3.1 PP21/1168 - 14 - 16 Denmark Hill Road, Kew (Construction of 16 dwellings over two lots)

Application no.:	PP21/1168	
Responsible director:	Scott Walker, Director Urban Living	
Authorised by:	David Cowan, Manager Planning and Placemaking	
Report officer:	Kelly Caporaso, Principal Urban Planner

PLANNING ASSESSMENT REPORT

Tree 20 - Large subject site tree

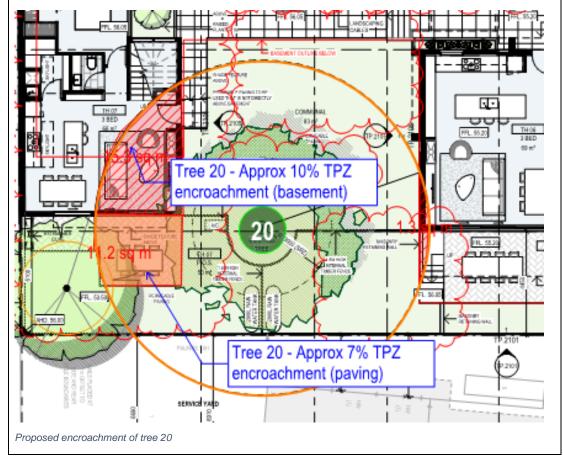
This tree has been identified with moderate/high arboricultural value within Glenn Waters Report, has been designated for retention and has been previously refused for removal under the local law. The proposed basement and ground floor of TH6 and TH7 represents a TPZ encroachment of approximately 10%, and is unlikely to have significant impacts.

The proposed paving area within the rear of TH7 represents a further TPZ encroachment of approximately 7%. Paving must be above grade and consist of a suitably permeable finish in order to be supported.

All existing levels within the TPZ and SRZ outside of the ground floor building envelope must be maintained.

No construction is to occur within the SRZ.
